Info Only: Engineering comments
are in blue text.

FINAL DRAINAGE REPORT
for
OWL MARKETPLACE FILNG NO. 1
PRE-SUBDIVISION GRADING

El Paso County File No. VR2321

Please update to
CDR247

Hydraulic Grade Line Computations

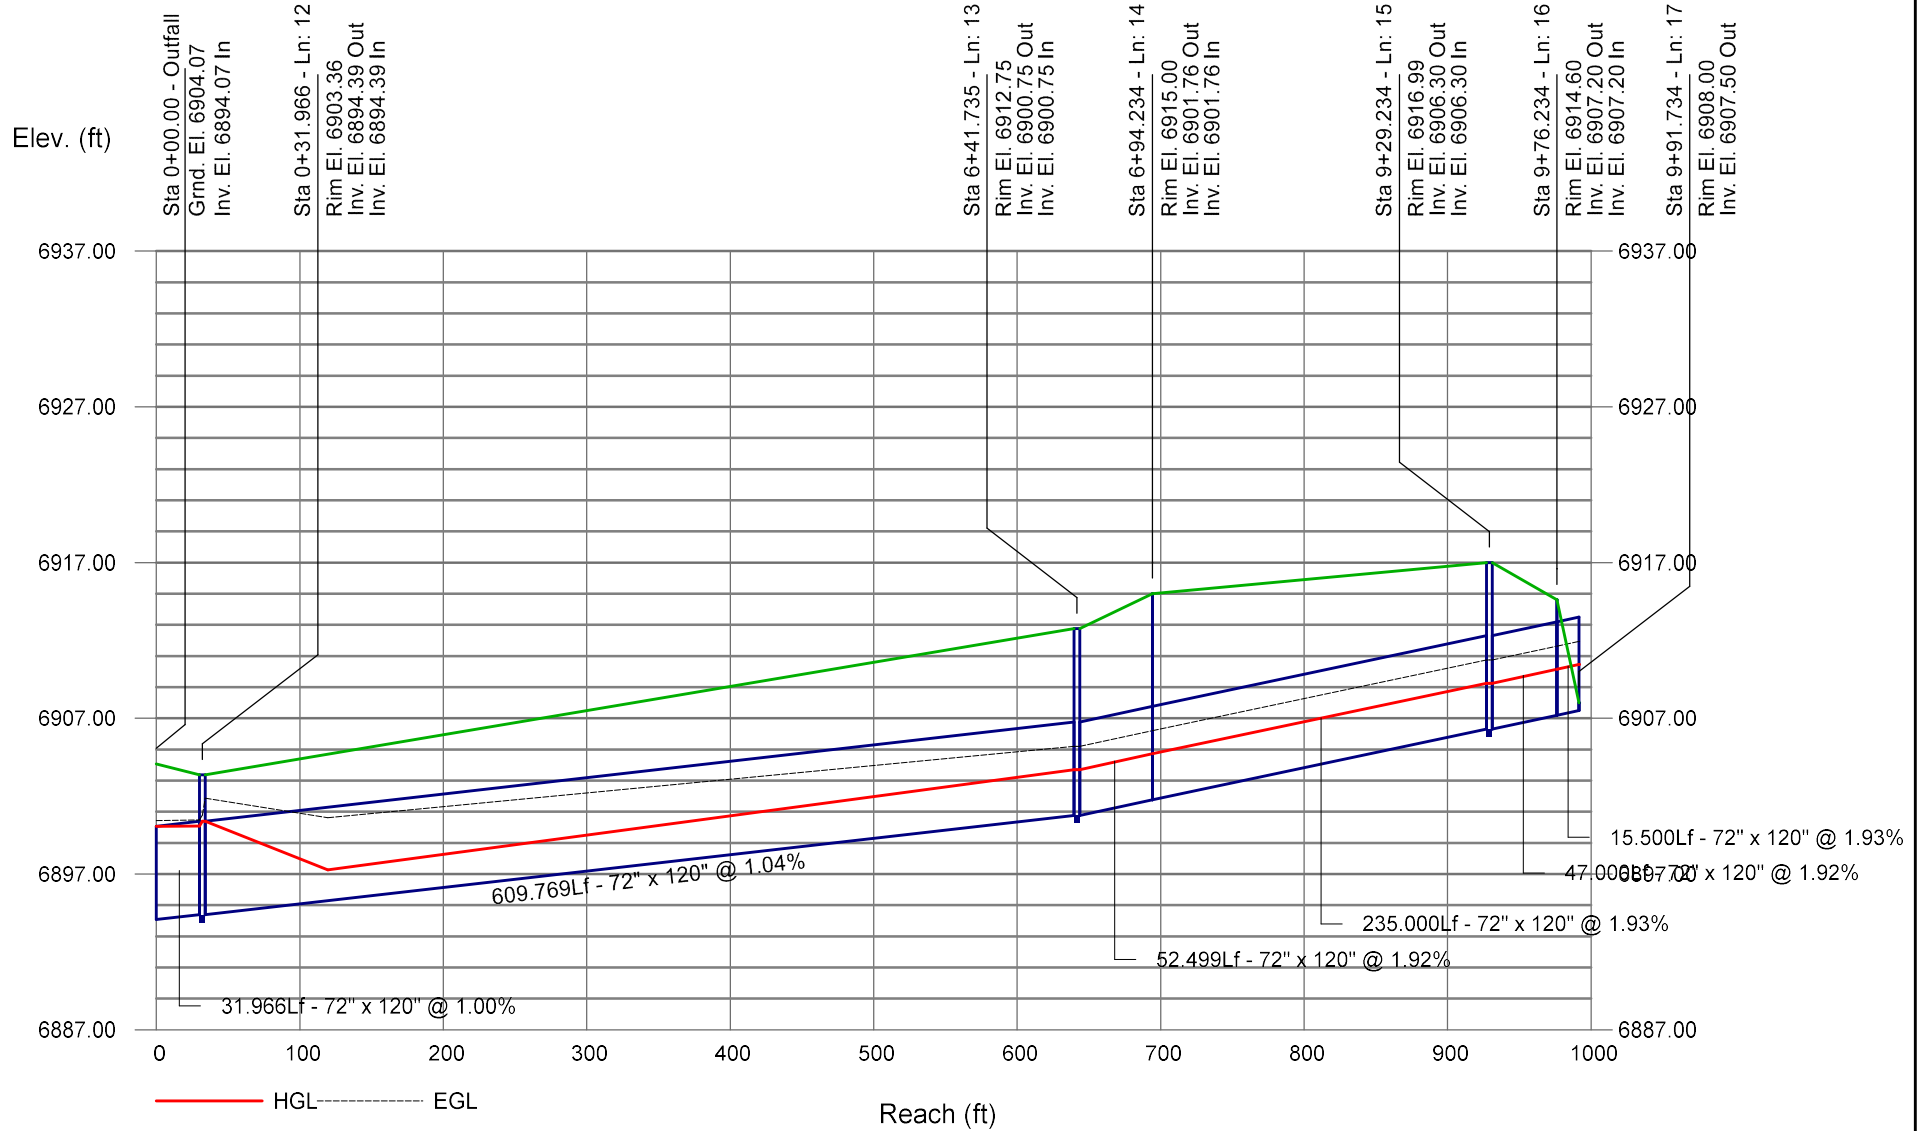
The velocity shall not fall below the minimum requirement of 4 ft/s or a minimum slope of 0.5%. Please adjust the VR2321 accordingly.

Project File: OP 100-YR REV3.stm

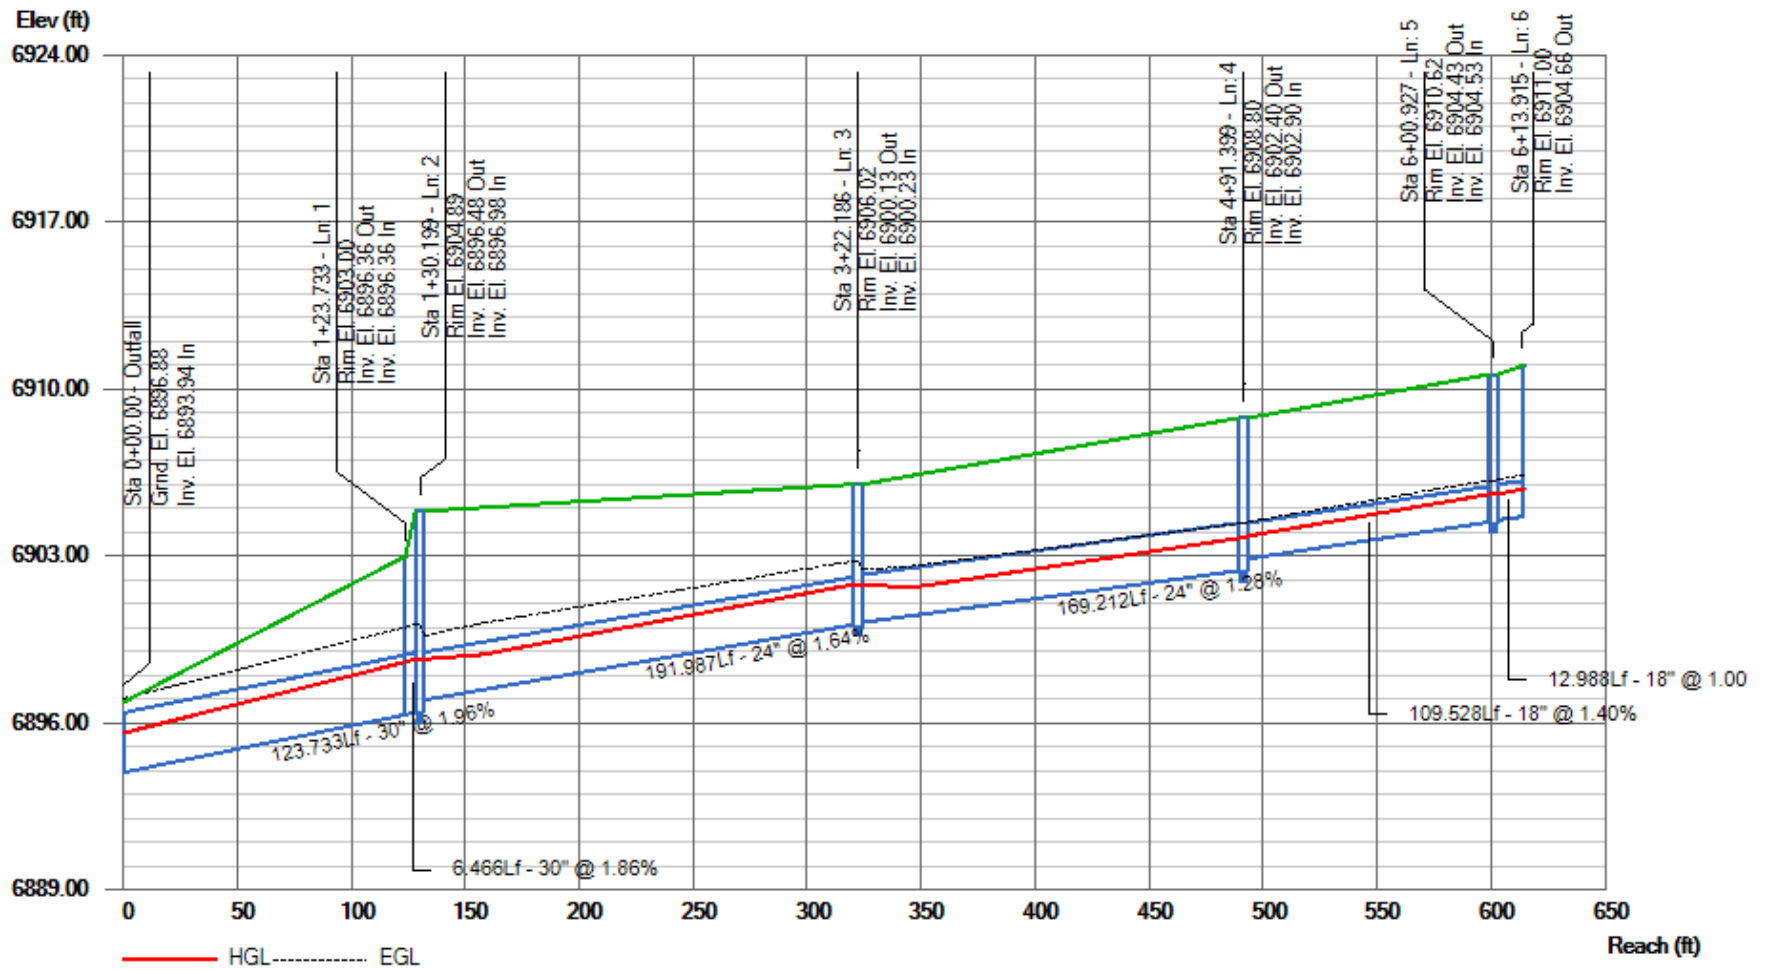
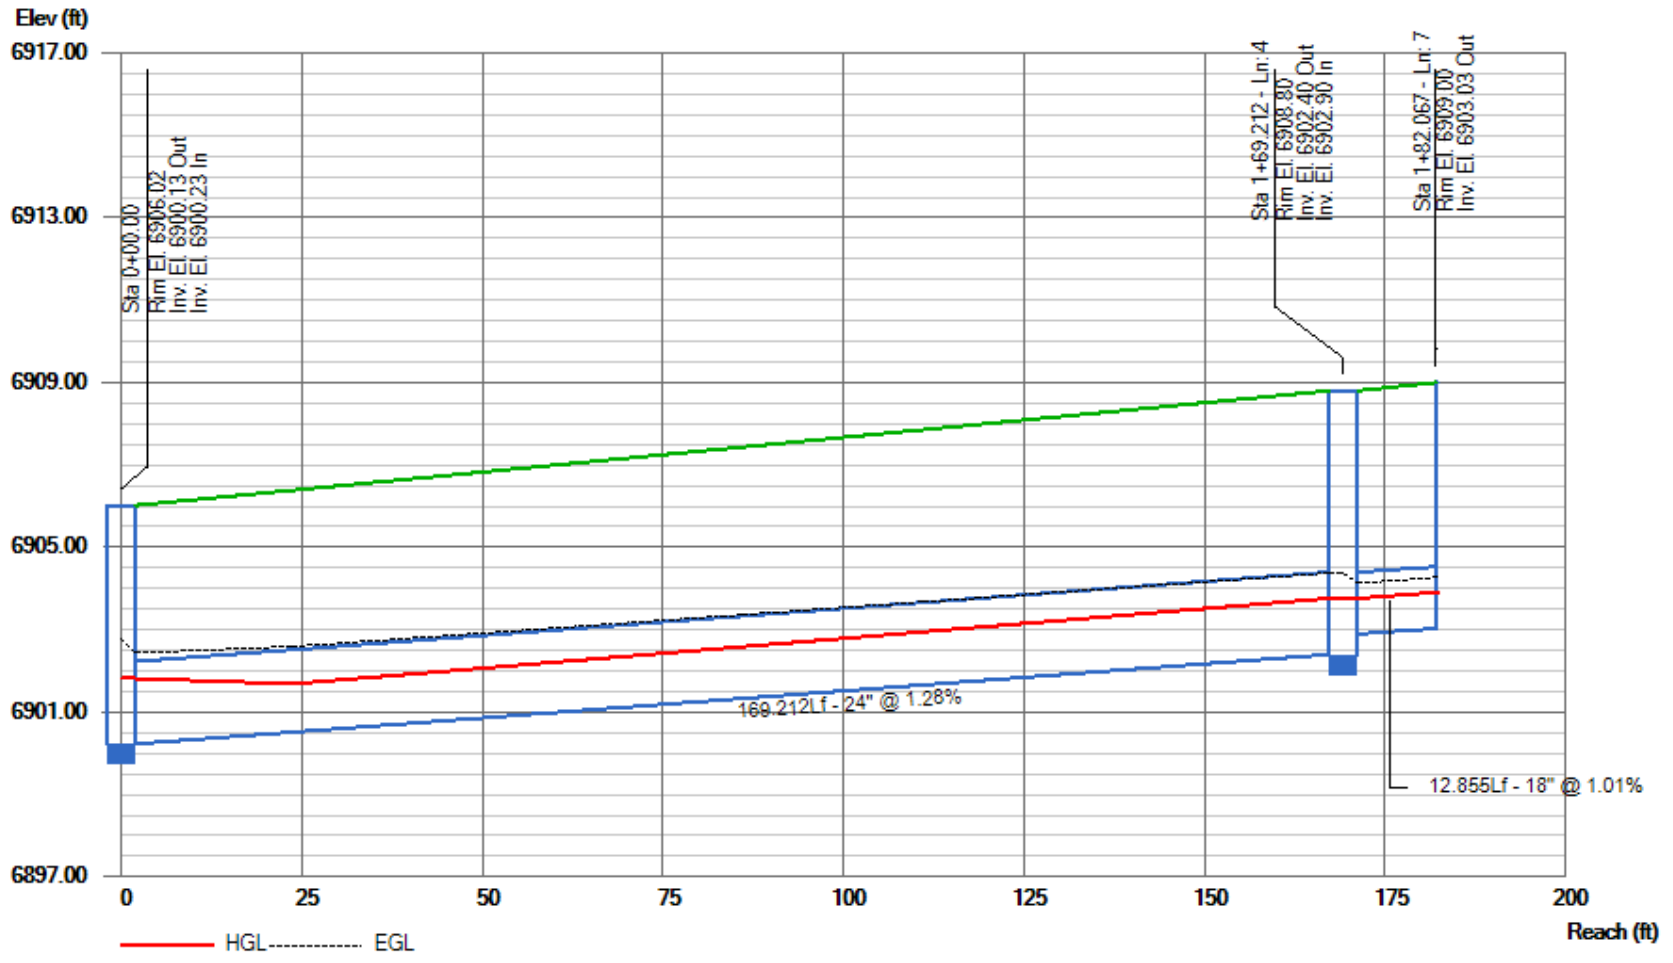
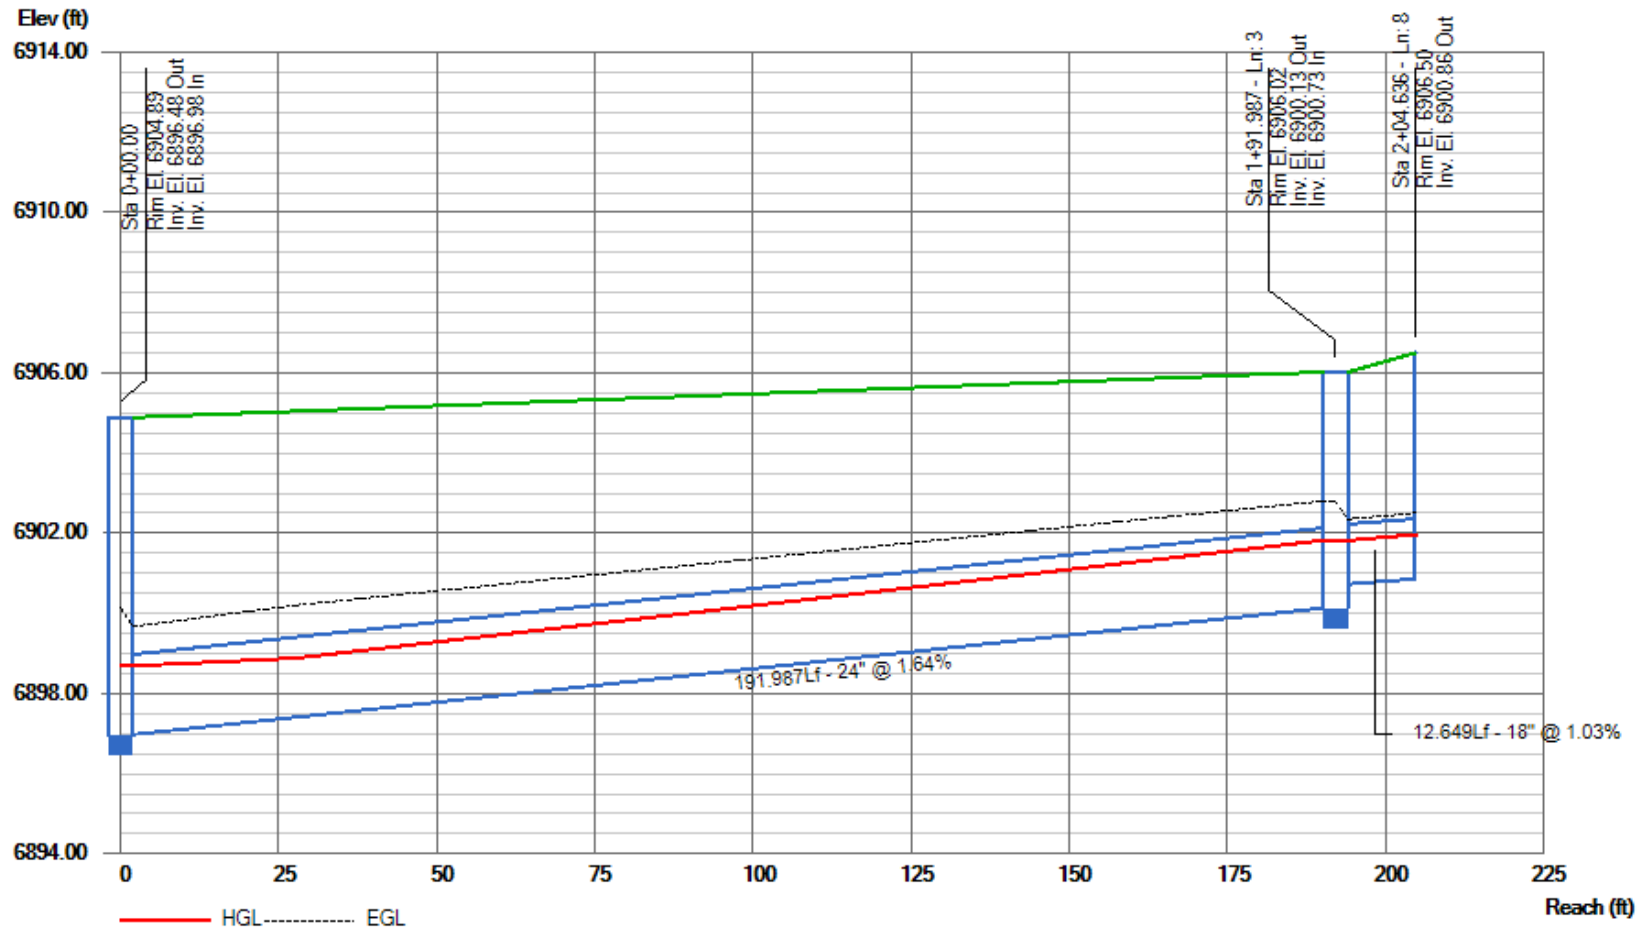
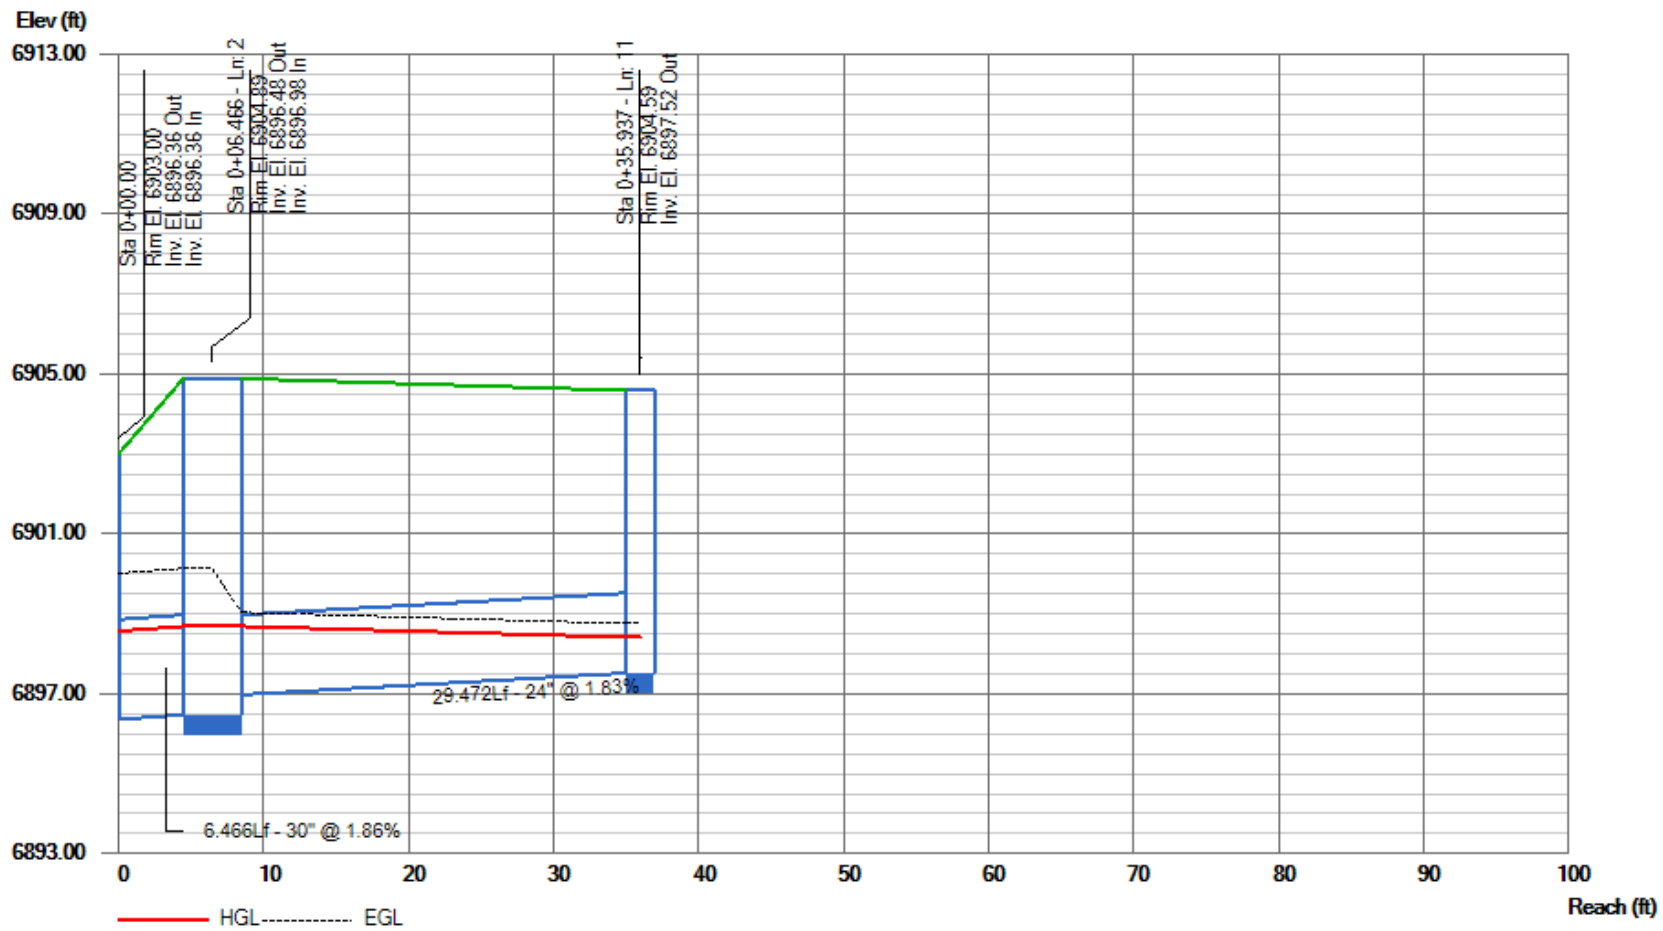
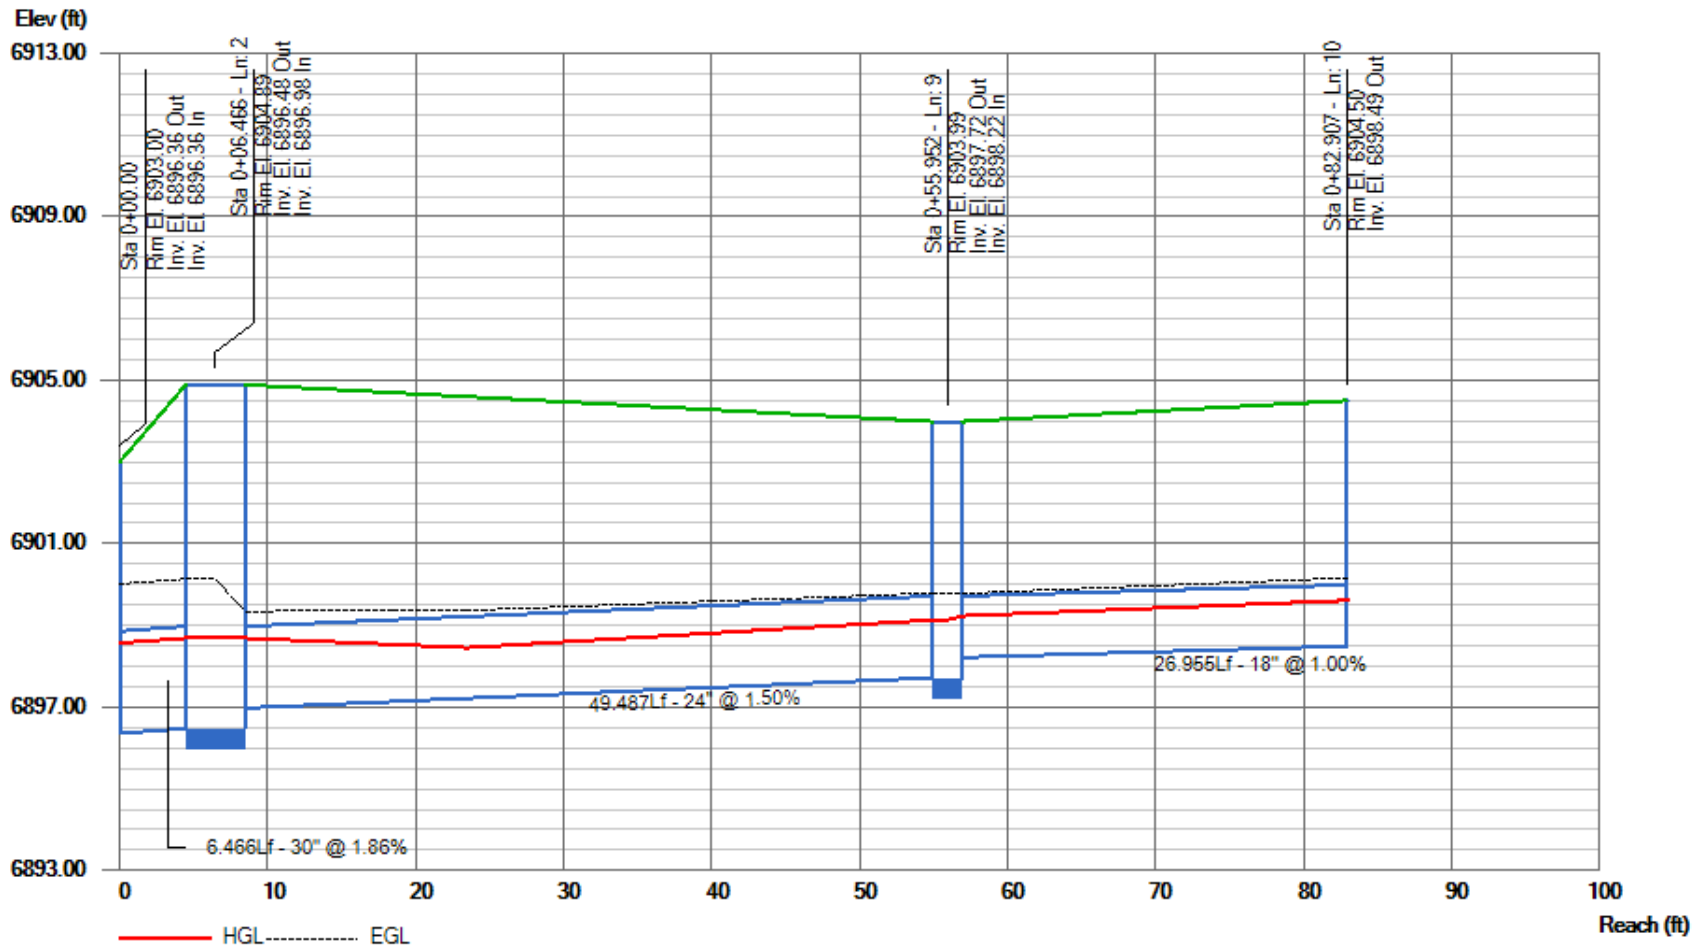
The velocity shall not fall below the minimum requirement of 4 ft/s or a minimum slope of 0.5%. Please adjust the VR2321 accordingly.
